Sept. 20 Public Hearing: Albion Area Plan Update

Official Community Plan Amending Bylaw No. 7698-2021; 2nd reading

Figure 2 - Proposed Bike Lanes, Multi-Use Paths and Trails

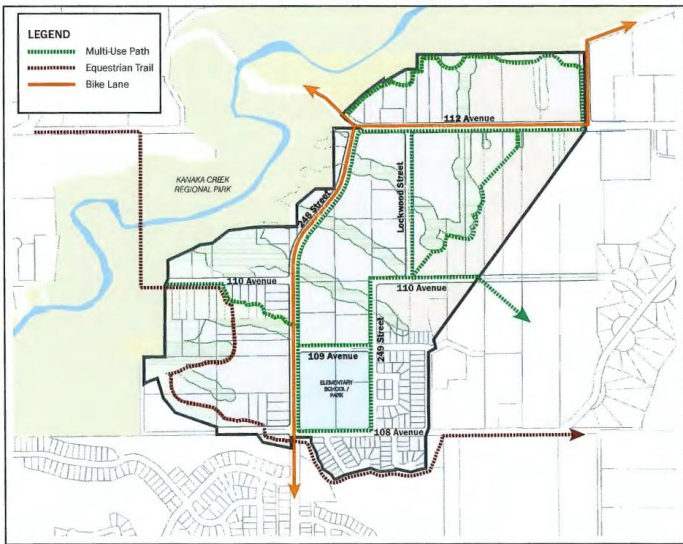
Here is the map showing the bike lanes:

Typical Section, 248 Street

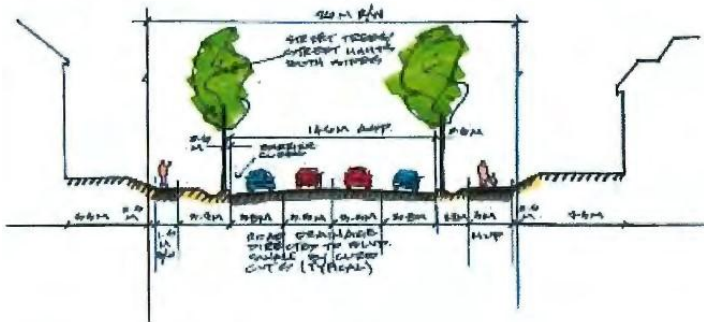
And here is the diagram, showing parking but no bike lanes:

The diagram in question has not been corrected to date. The text in the diagram is also illegible. We request to have it corrected to include bike lanes, as well as to make the text legible, so that we can be confident that adequate space is accounted for in the road width and that bike lanes are indeed included in any future development along this arterial.

Also, a buffer will have to be included between parked cars and the curb in case of parking-protected bike lanes (which would be the preferred option). If the bike lanes are to be situated between the parked cars and moving cars, buffers will be needed on both sides for safety.
